DOCKETED	
Docket Number:	11-AFC-04
Project Title:	Rio Mesa Solar Electric
TN #:	233566
Document Title:	Applicant's Supplemental Response to Data Request 16 and 26 Additional Information Regarding Paleontological Resources
Description:	Document was on proceeding webpage and is now moved over to the docket log.
Filer:	Marichka Haws
Organization:	California Energy Commission
Submitter Role:	Commission Staff
Submission Date:	6/19/2020 3:39:56 PM
Docketed Date:	6/19/2020

APPLICANT'S SUPPLEMENTAL RESPONSE TO DATA REQUEST 16 AND 26: ADDITIONAL INFORMATION REGARDING PALEONTOLOGICAL RESOURCES

In this section of Applicant's Supplemental Response to CEC Staff Data Requests 16 and 26, Applicant describes the changes to the Paleontological Resources section that will result from the changes to the Project Description relating to the removal of Unit 3. Per staff's request, Applicant uses a strike-out/underline format to identify changes to the Paleontological Resources section of the Application for Certification that will result from the changes to the Project Description.

FIG. NO:
5.8-1
(REV)

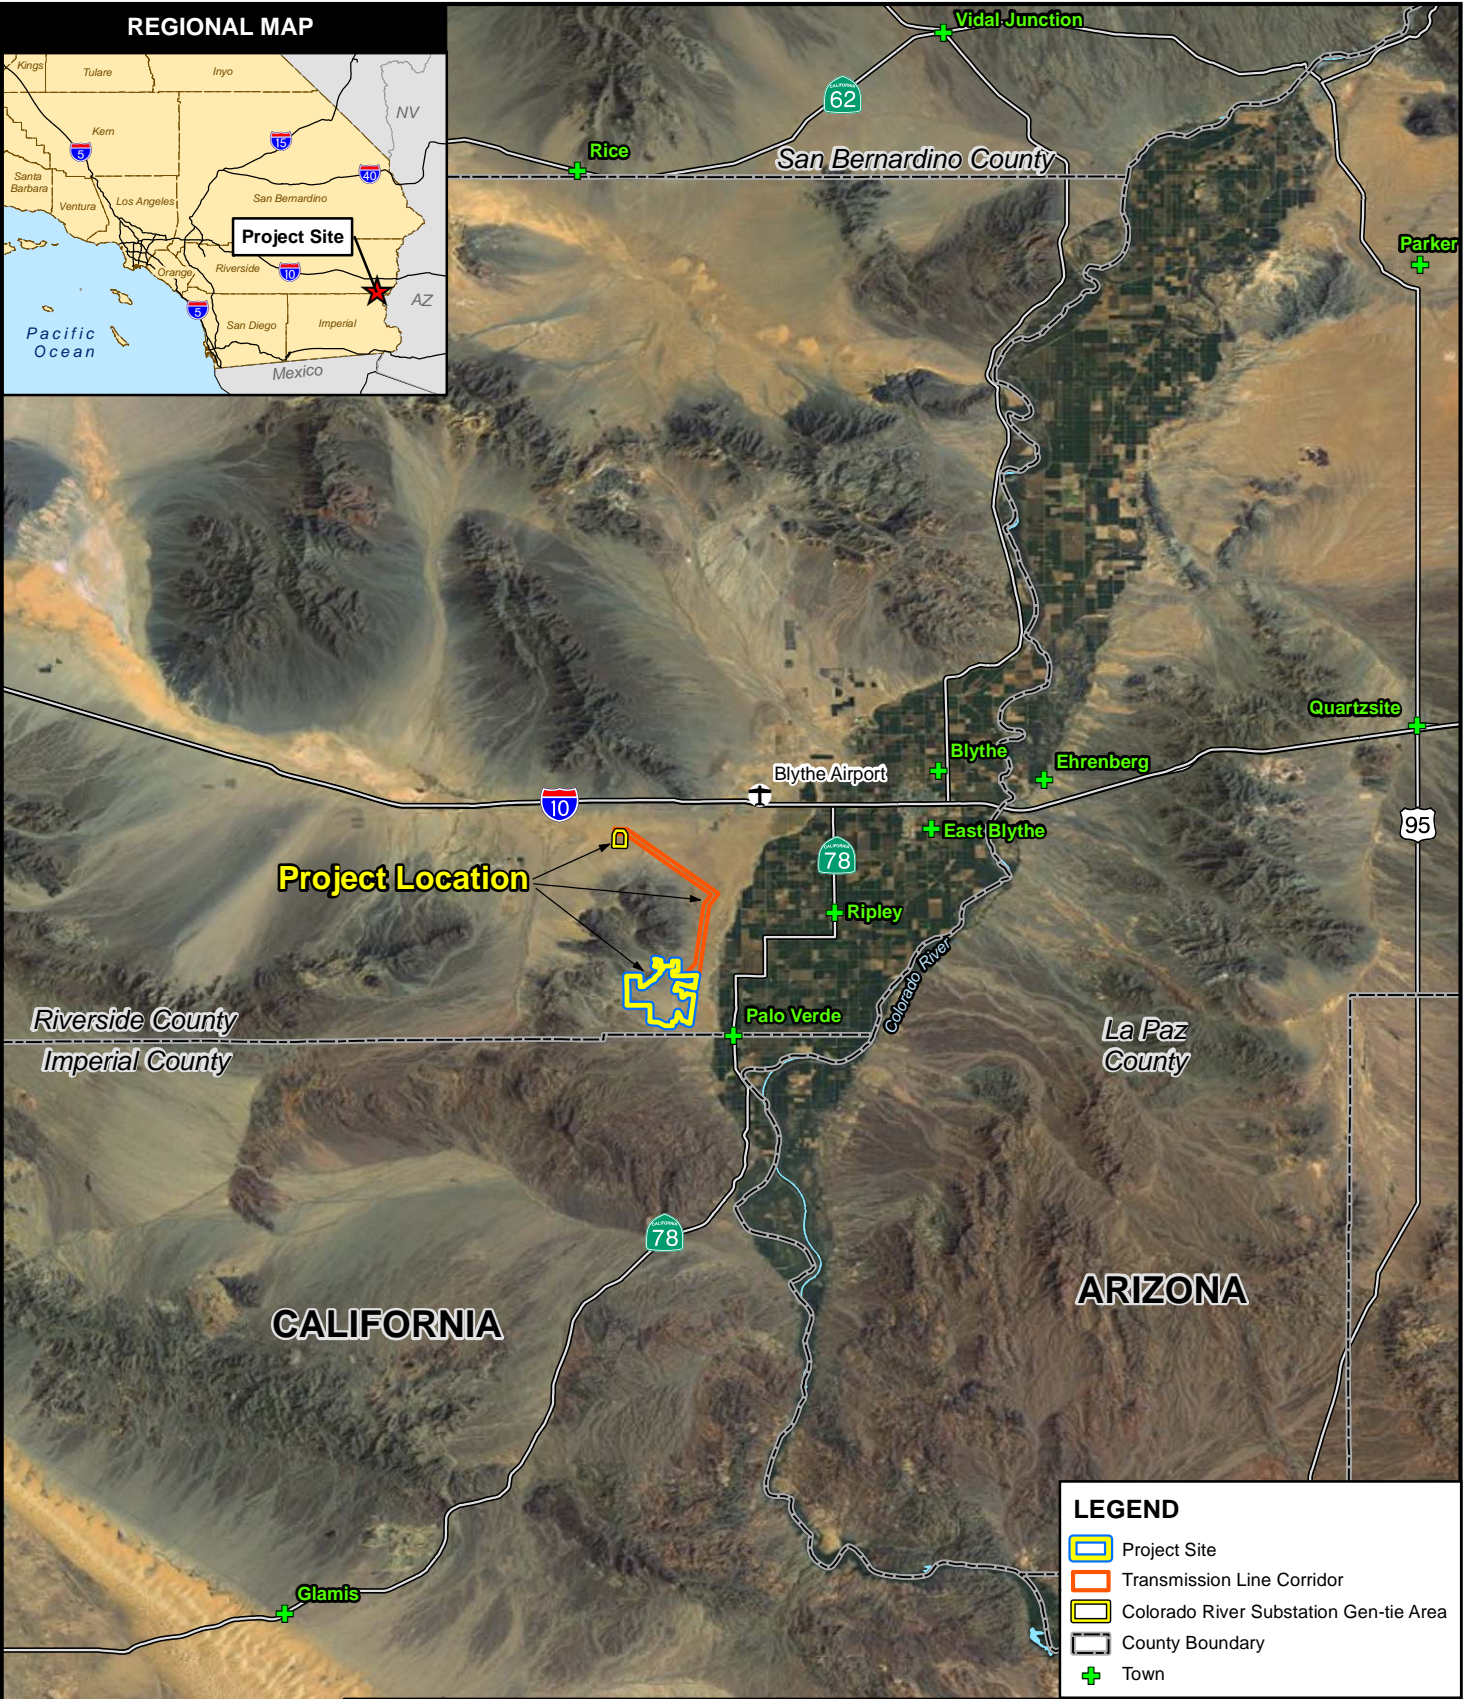
Figure 5.8-1 [\(rev\)](#) Regional & Vicinity Map Rio Mesa Solar Electric Generating Facility

The Project is located in the Palo Verde Mesa, above and east of the Palo Verde Valley, an area on the west bank of the Colorado River in eastern California (see Figure 5.8-1 ([rev](#))). The Mule Mountains are to the west and the Palo Verde Mountains are to the south and southwest. Some references consider the Palo Verde Mesa to lie within the Colorado Desert physiographic province; others consider it to lie within the Mojave Desert physiographic province. The salient difference between the two is that the Mojave Desert is high desert, whereas the Colorado Desert is low desert (Norris and Webb, 1990). Given that the

CREATED BY: CM	DATE: 06-20-12	FIG. NO: 5.8-2
PM: AL	PROJ. NO: 27651004.00000	(REV)

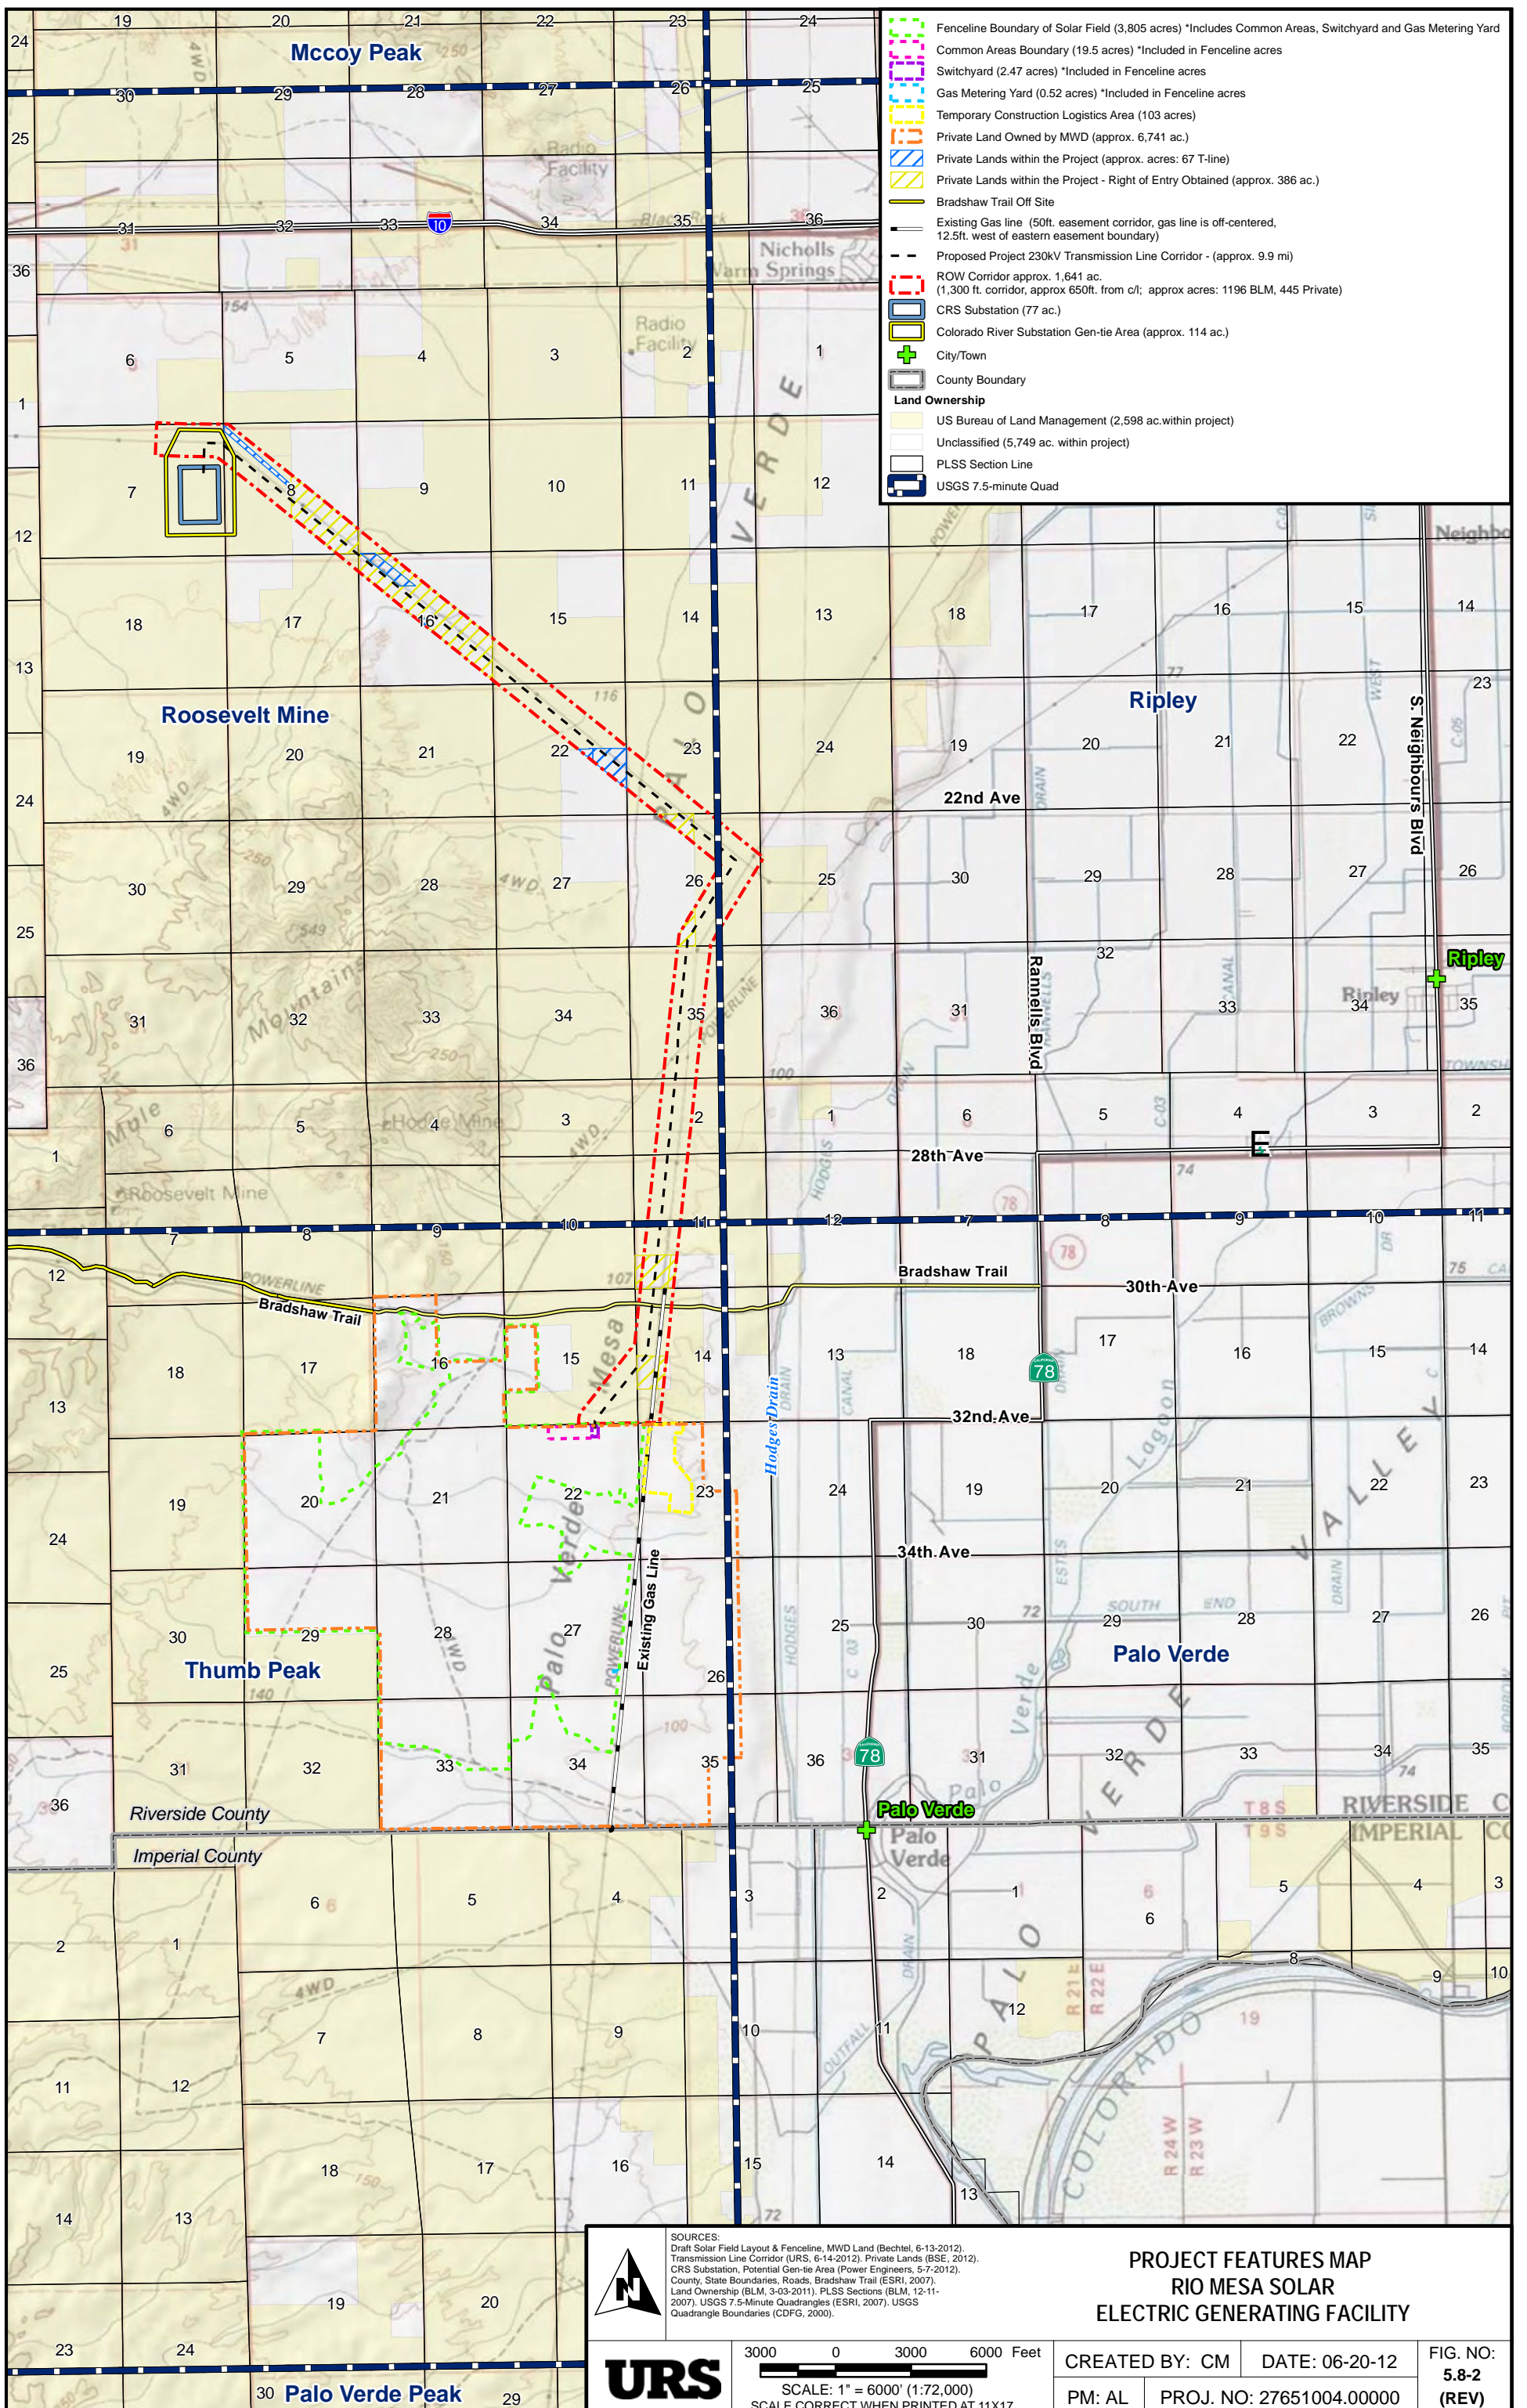
Figure 5.8-2 [\(rev\)](#) Project Features Map Rio Mesa Solar Electric Generating Facility

~~The Project lies in T8S, R21E, Sections 2, 3, 10, 11, 14-17, 19-23, 26-29, and 33-35. The power transmission line proposed as part of the Project crosses parts of Sections 7-9, 15-17, 22, 23, 26, and 35, T7S, R 21E.~~ The Project footprint lies on the Roosevelt Mine, Ripley, Thumb Peak, and Palo Verde 7.5' USGS topographic quadrangles (see Figure 5.8-2 ([rev](#))).
